**ADDENDUM 1**

**DATE: June 18, 2021**

Contract: 21-C-00017 Beach Park Stormwater Improvements

Item 3: Replace plan sheets 6, 7, 8, 9 and 20 with the attached plan sheets 6, 7, 8, 9 and 20.

DES: Y.P.	<b>CITY of TAMPA</b> Mobility Department Stormwater Engineering Division	BEACH PARK STORMWATER DRAINAGE IMPROVEMENTS PLAN VIEW - WESTSHORE BLVD. STA. 0+00 - 2+50	SHEET
DRN: BB			6
CKD:			OF 21
DATE:

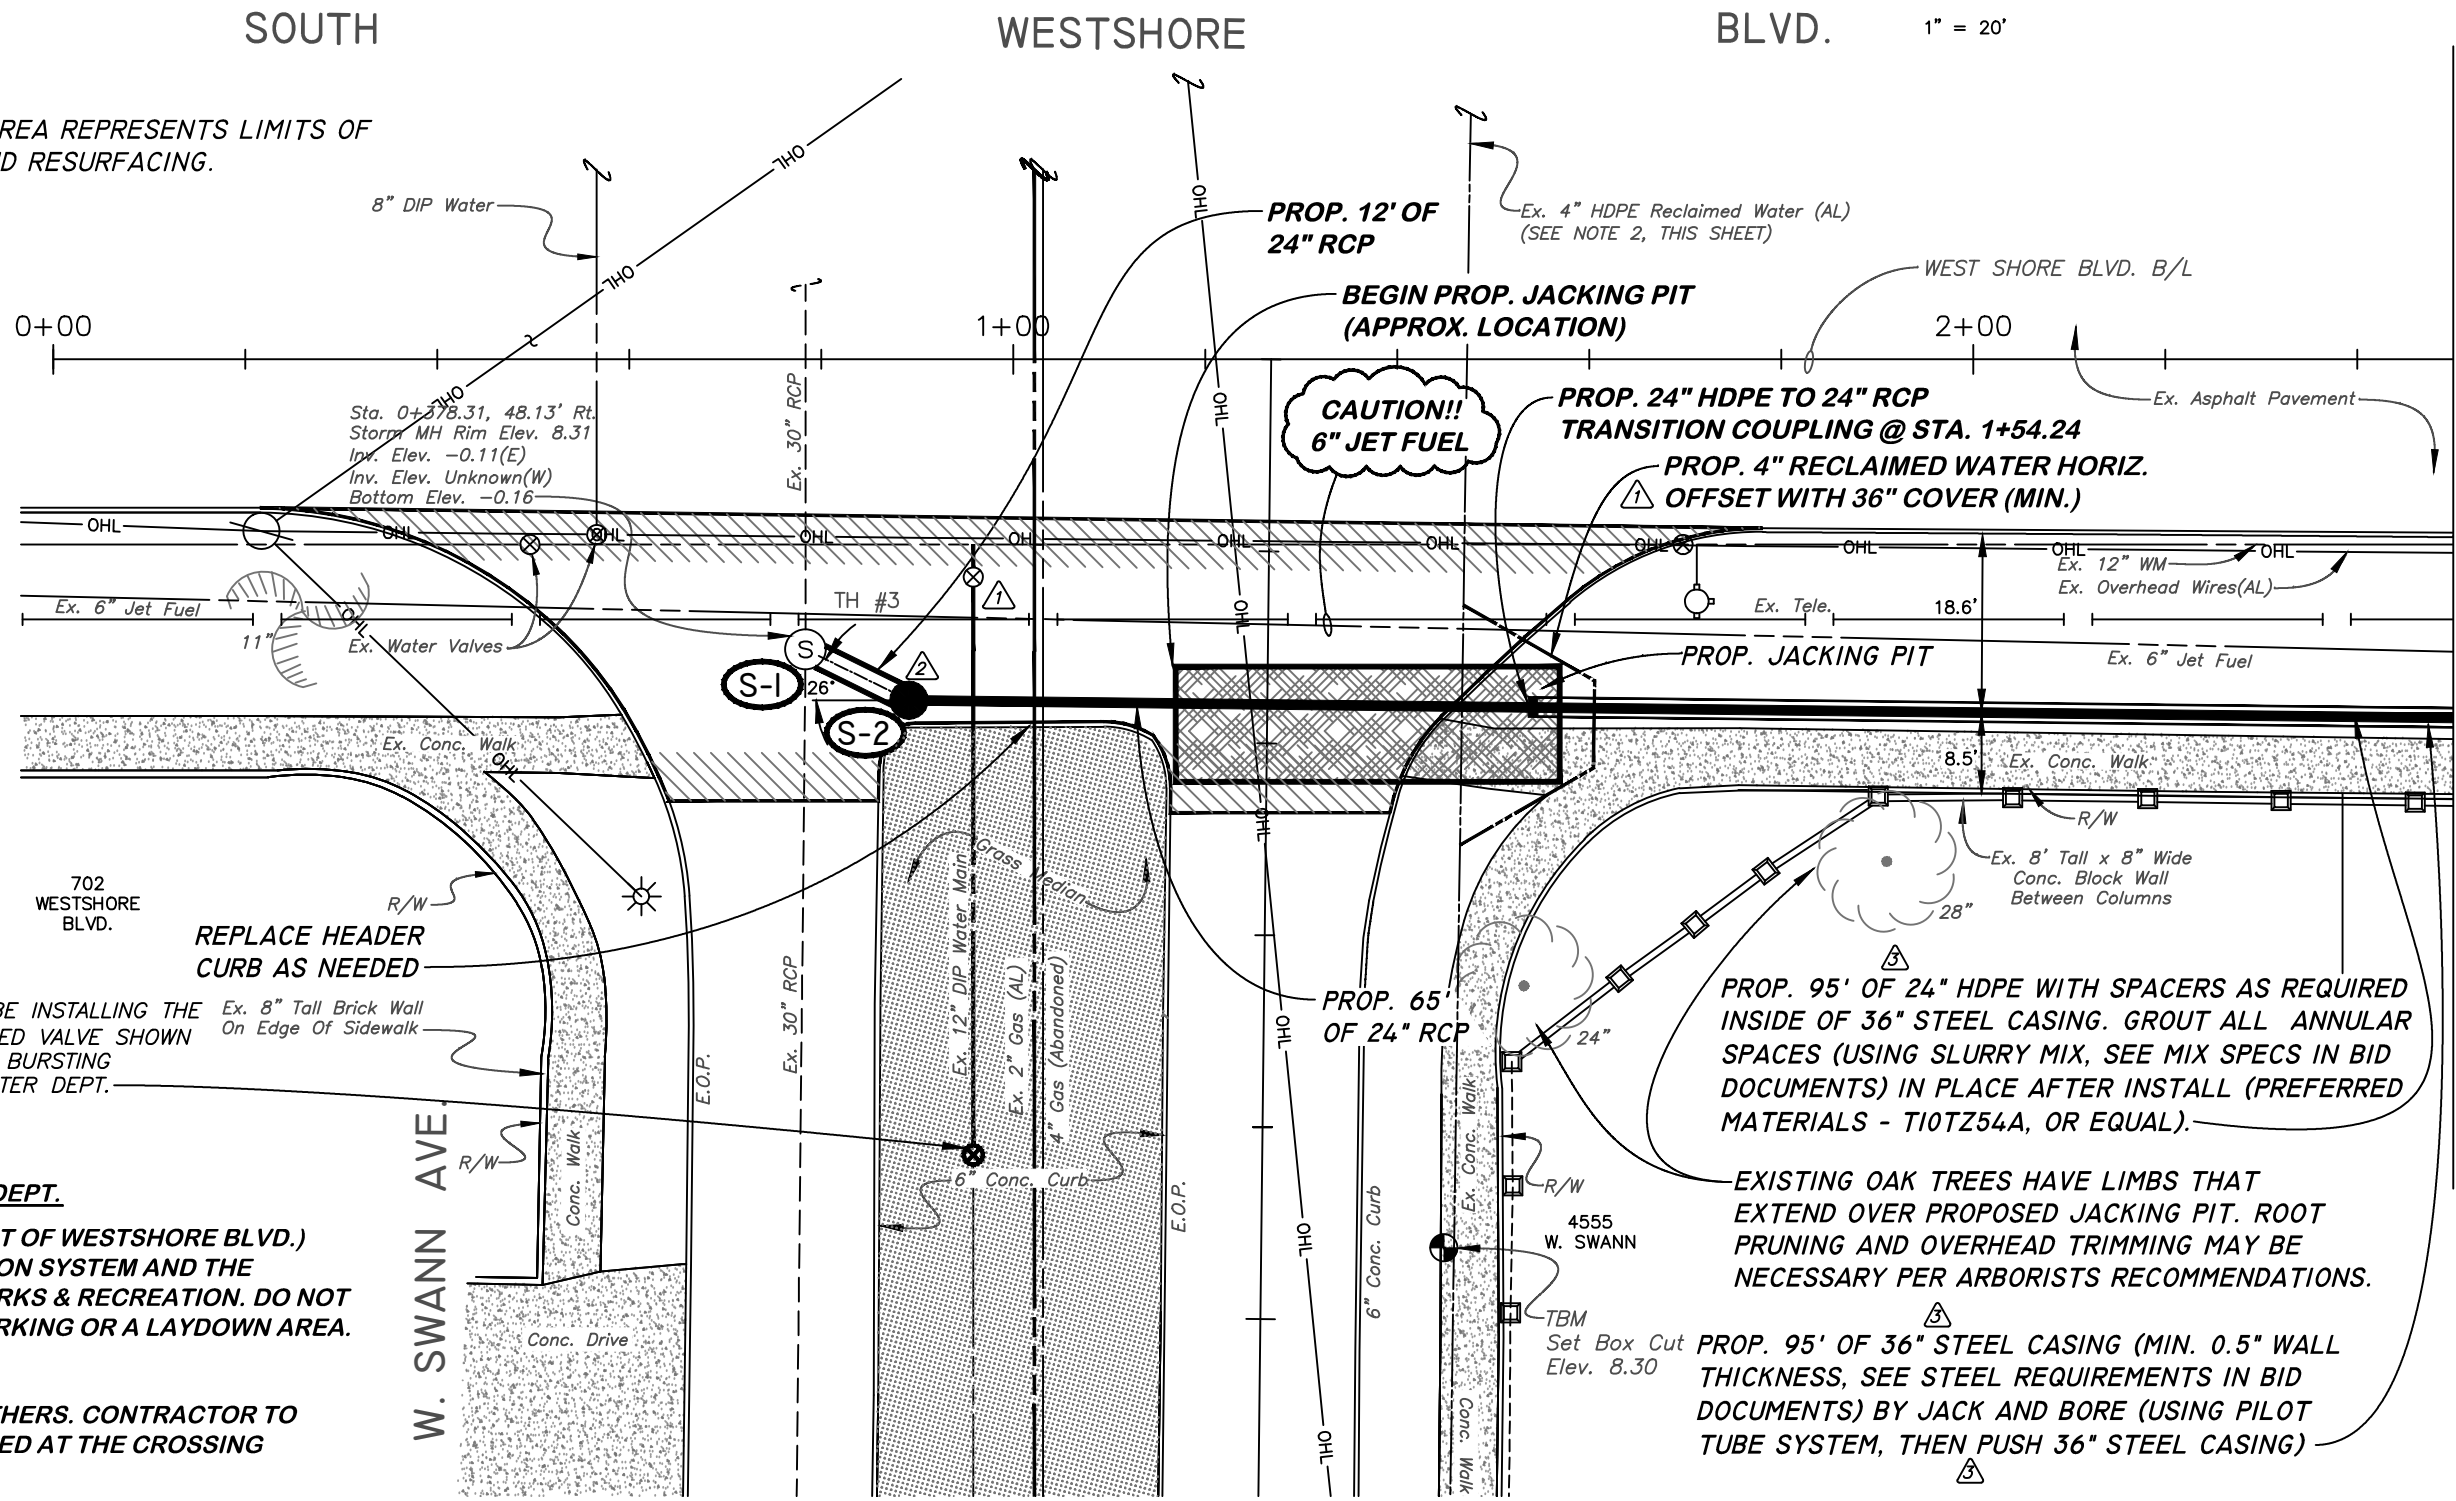
No.	DATE	REVISIONS	No.	DATE	REVISIONS
△	06/16/21	REVISED PIPE TO "STEEL," CHANGE "PULL" TO "PUSH"	6		
△	05/06/21	RELOCATED S-2 5' SOUTH	5		
△	05/06/21	WATER LOCATION AND OFFSET, & NOTE REVISED	4

BEACH PARK  
STORMWATER DRAINAGE IMPROVEMENTS  
PROFILE - WESTSHORE BLVD. STA. 0+00 - 2+50

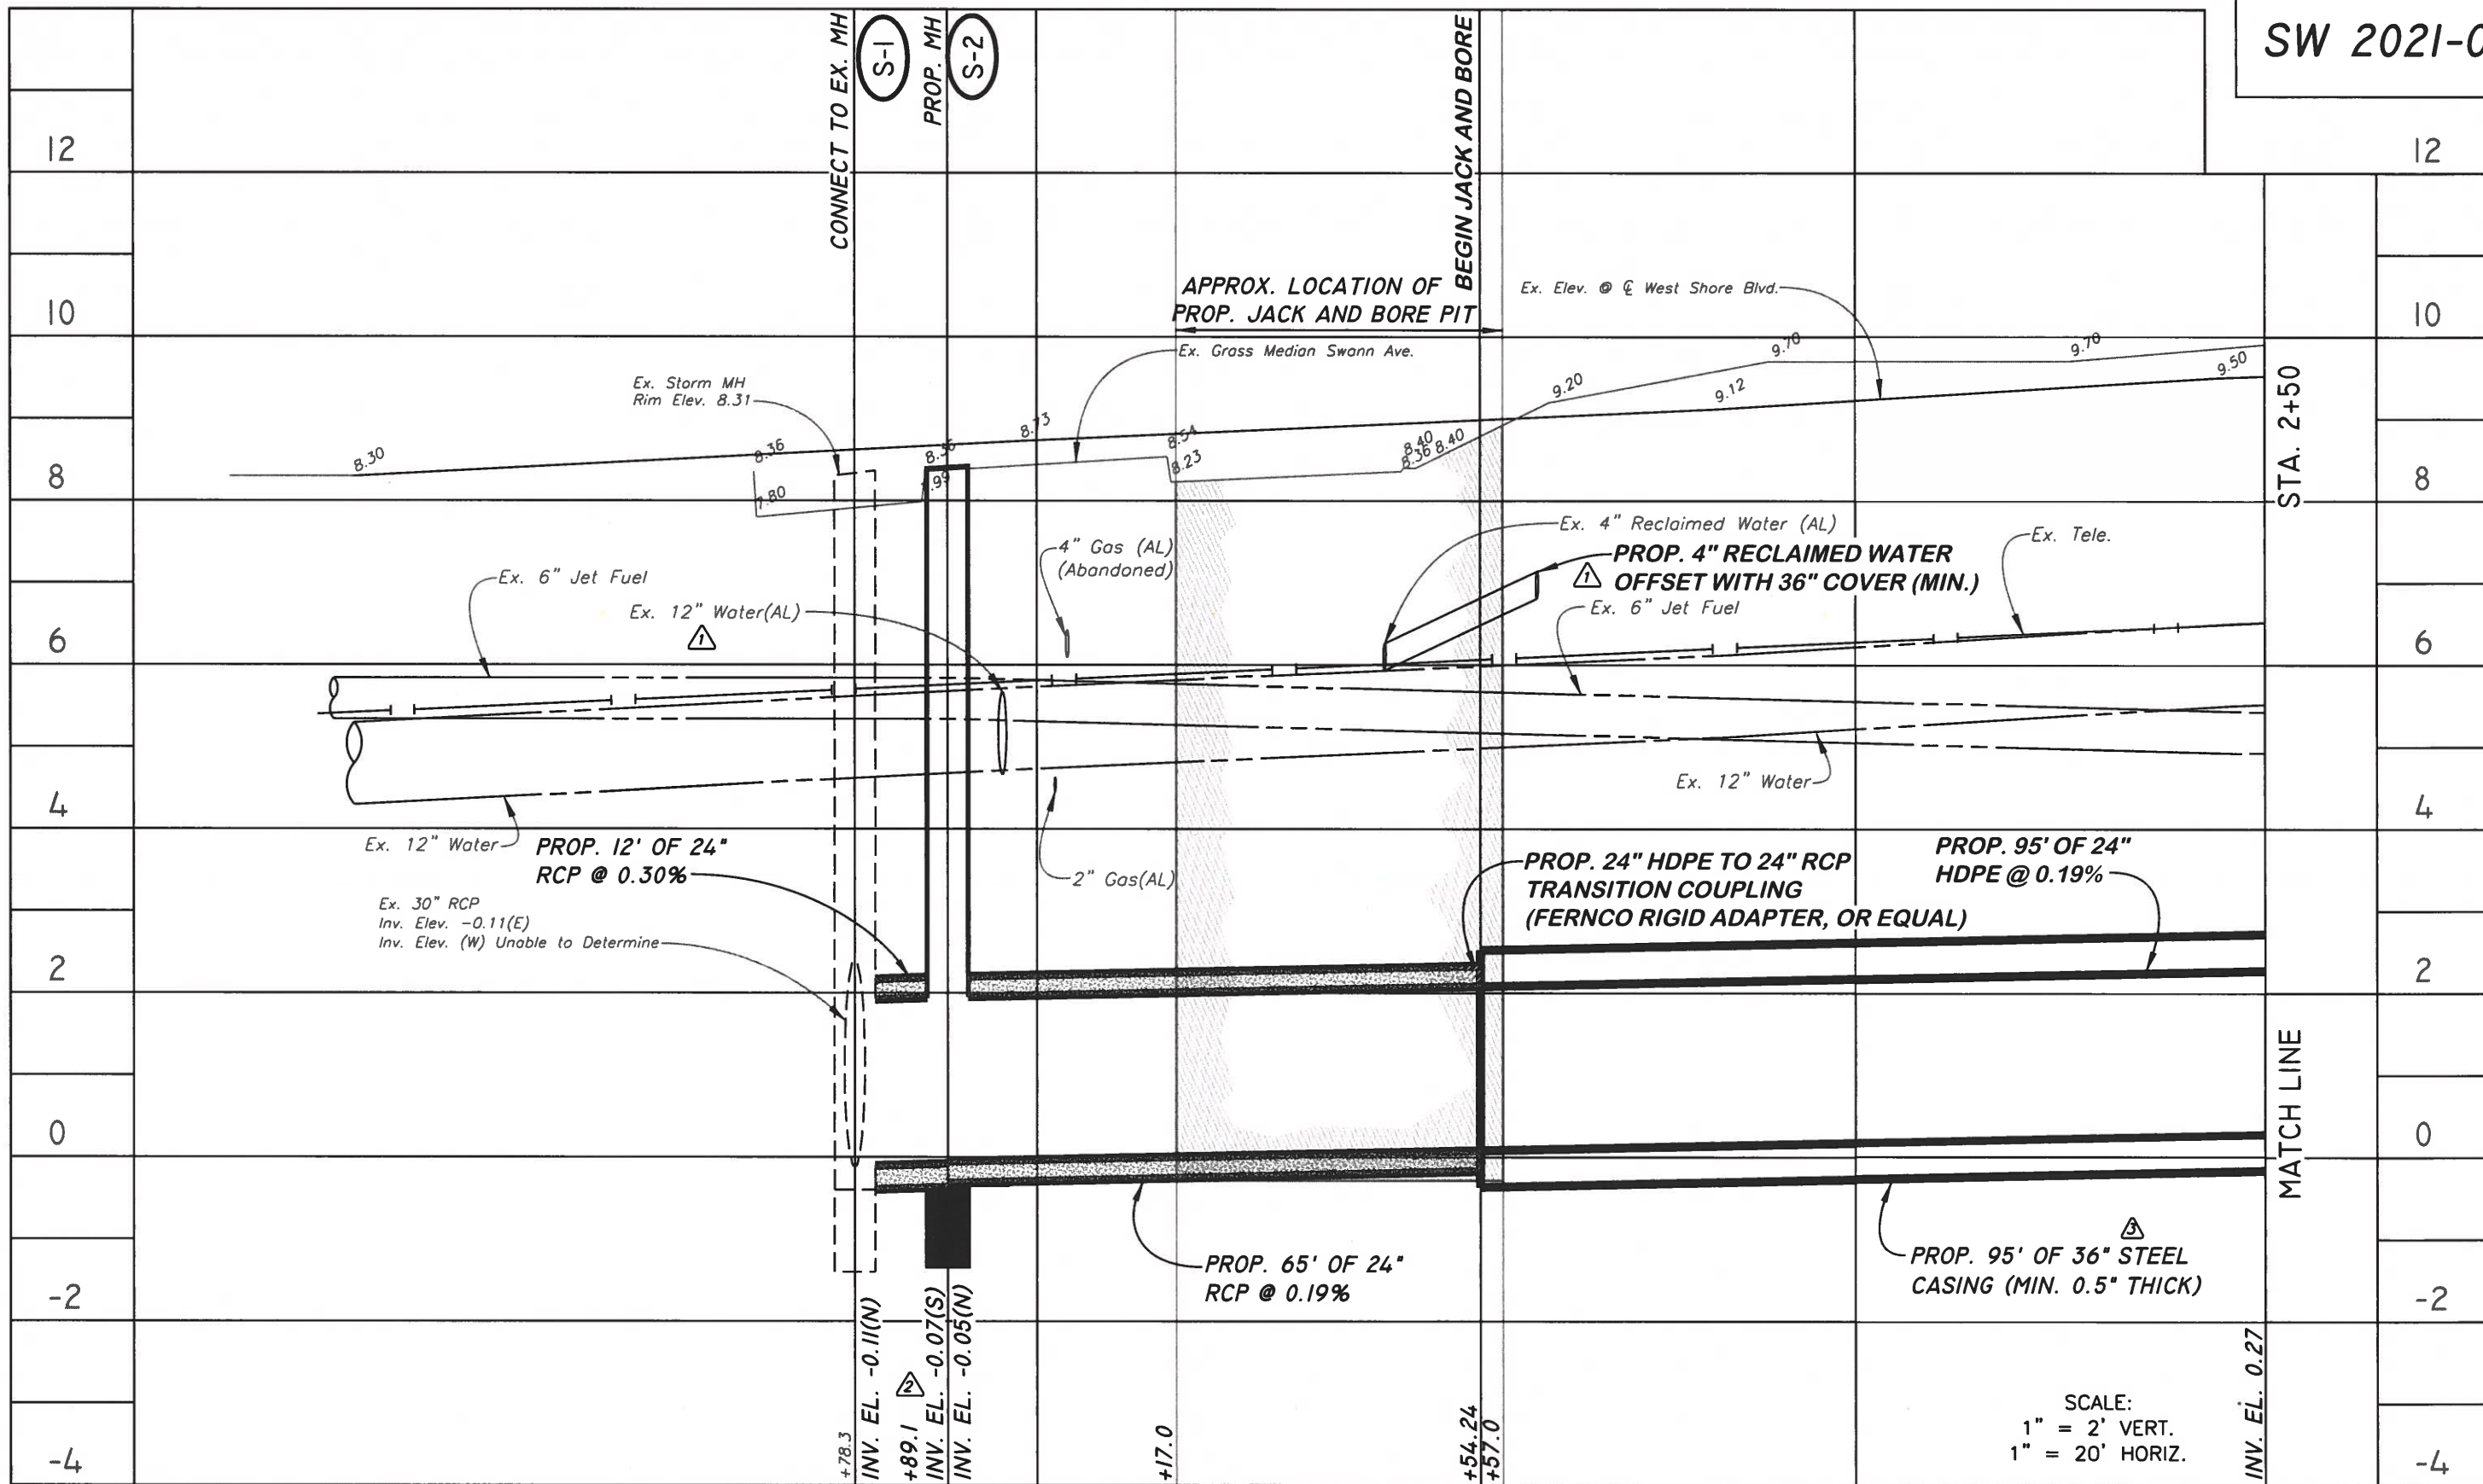
No.	DATE	REVISIONS	No.	DATE	REVISIONS
⚠	06/16/21	REVISED PIPE TO "STEEL" FROM STAINLESS	6		
⚠	05/06/21	RELOCATED S-2 5' SOUTH	5		
⚠	05/06/21	WATER LOCATION AND OFFSET REVISED	4

BEACH PARK  
 STORMWATER DRAINAGE IMPROVEMENTS  
 PROFILE - WESTSHORE BLVD.

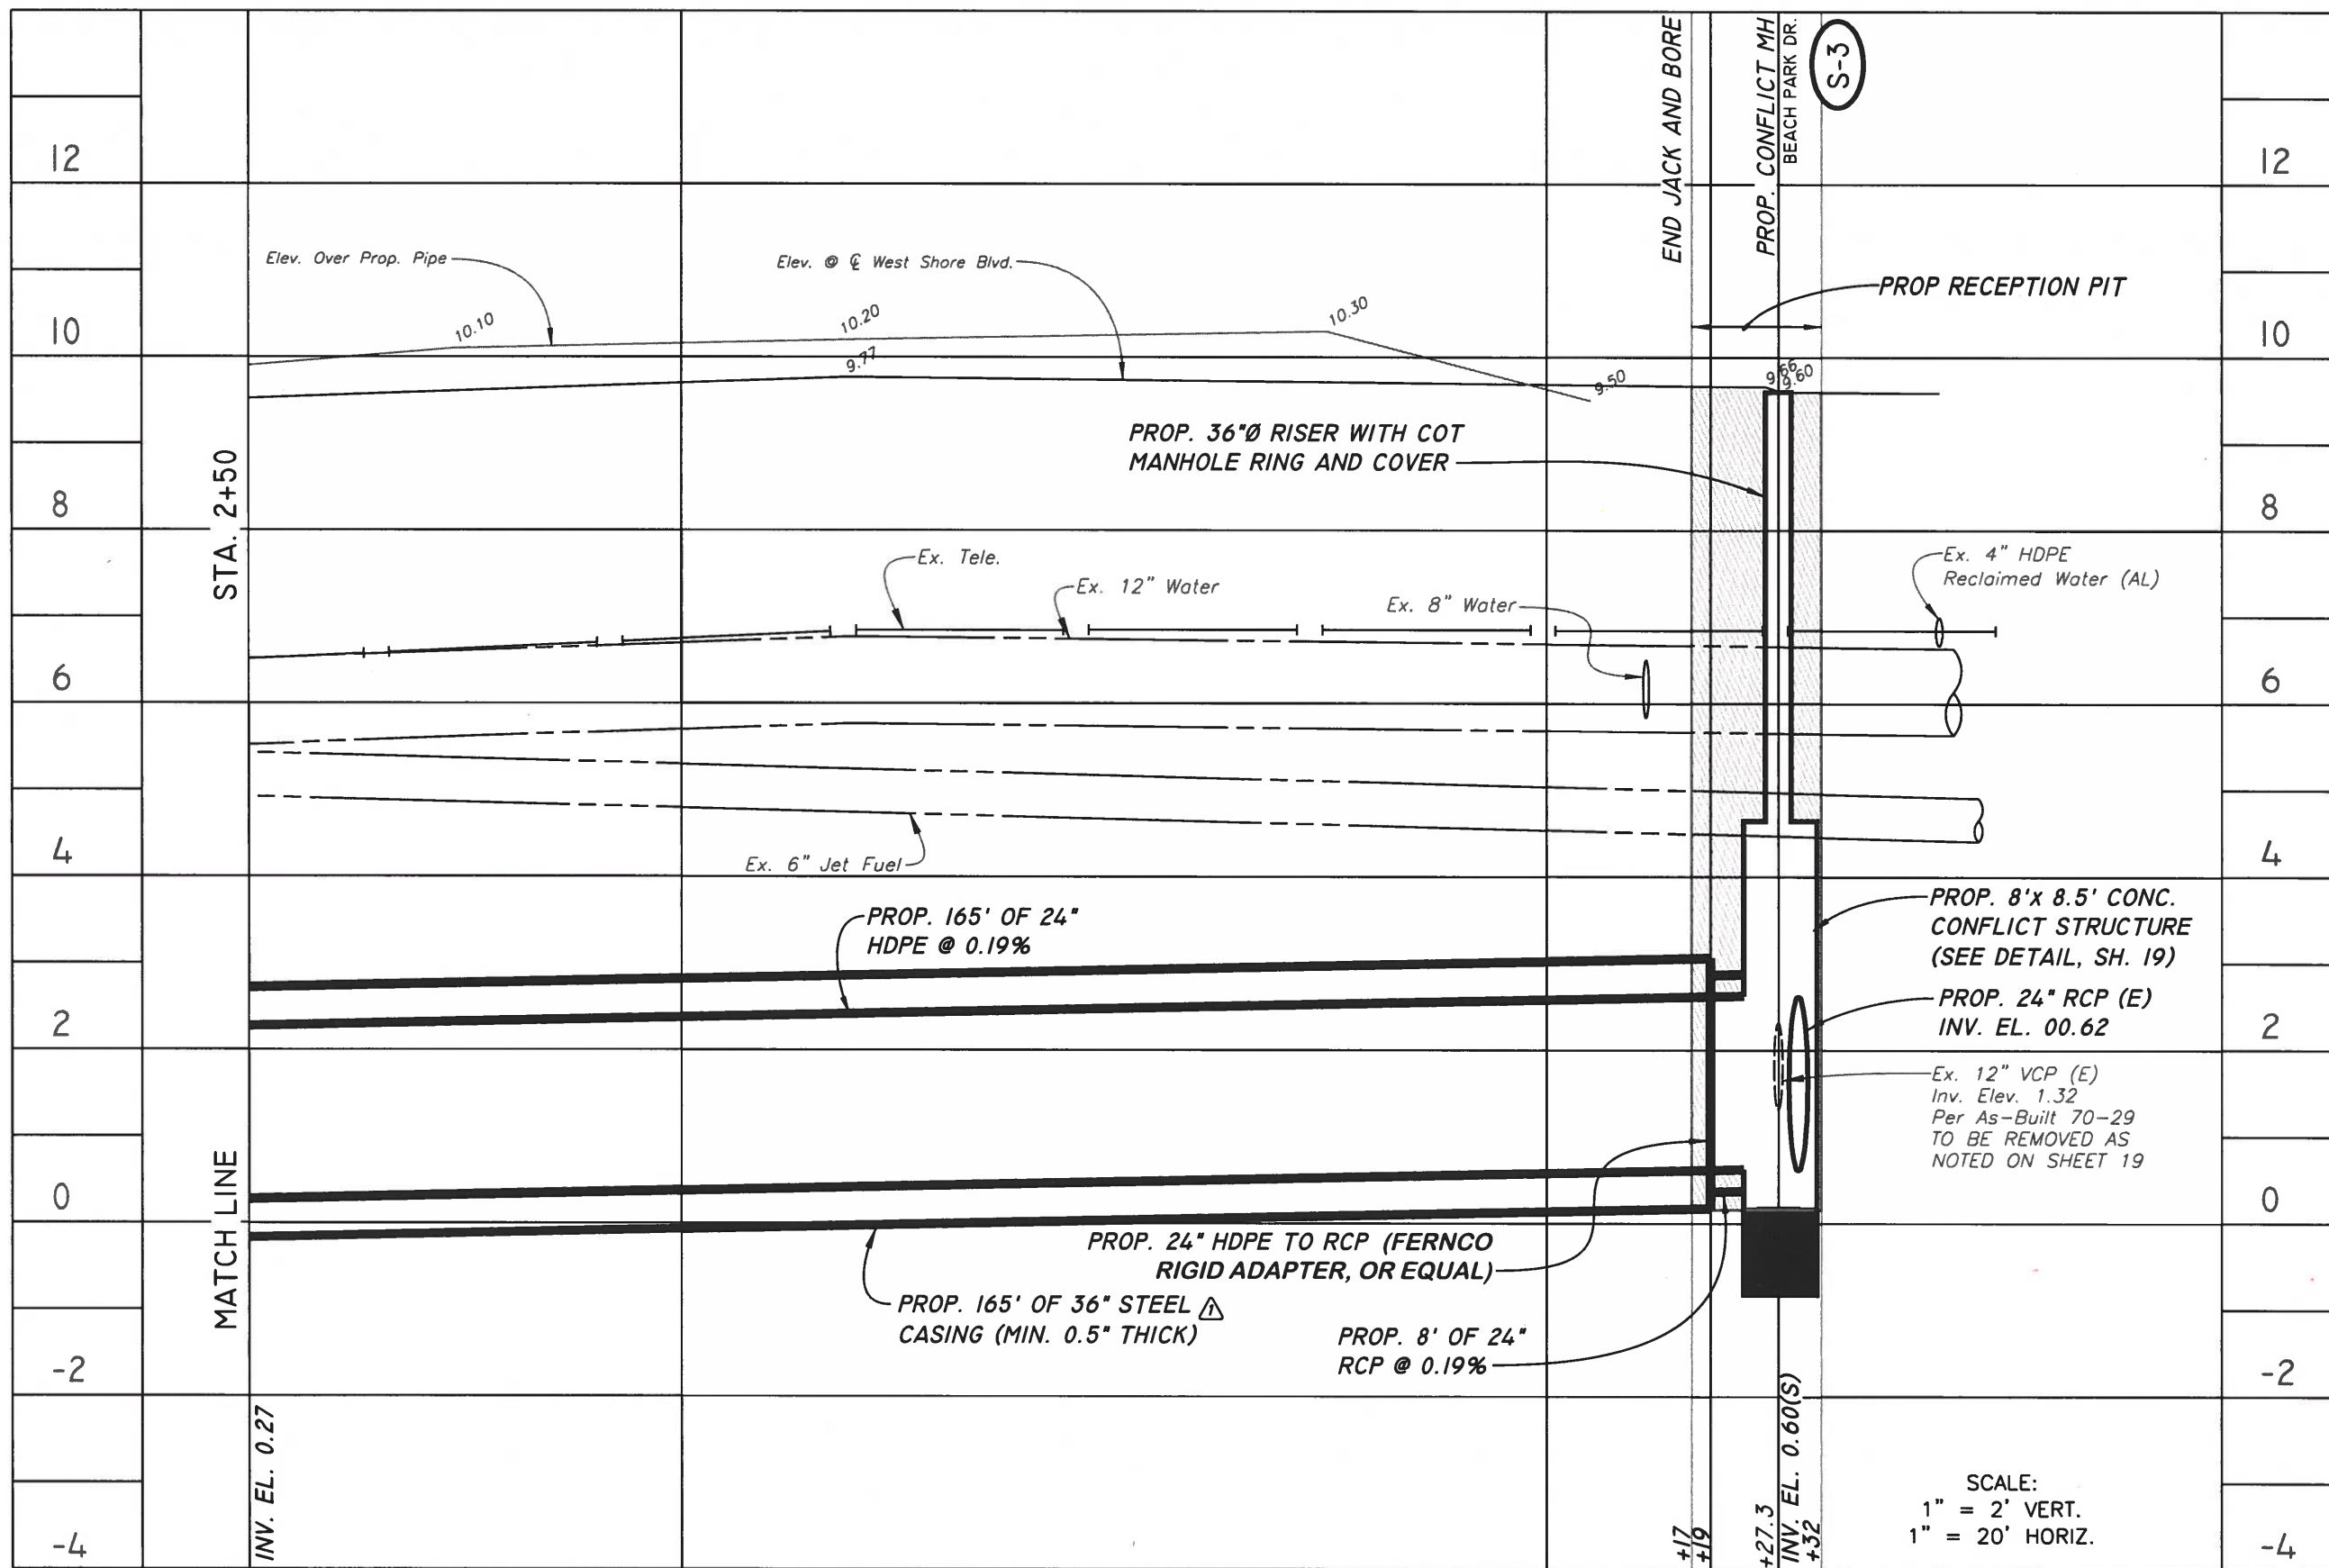
No.	DATE	REVISIONS	No.	DATE	REVISIONS
3			6		
2			5		
1	06/16/21	REVISED PIPE TO "STEEL" FROM STAINLESS	4
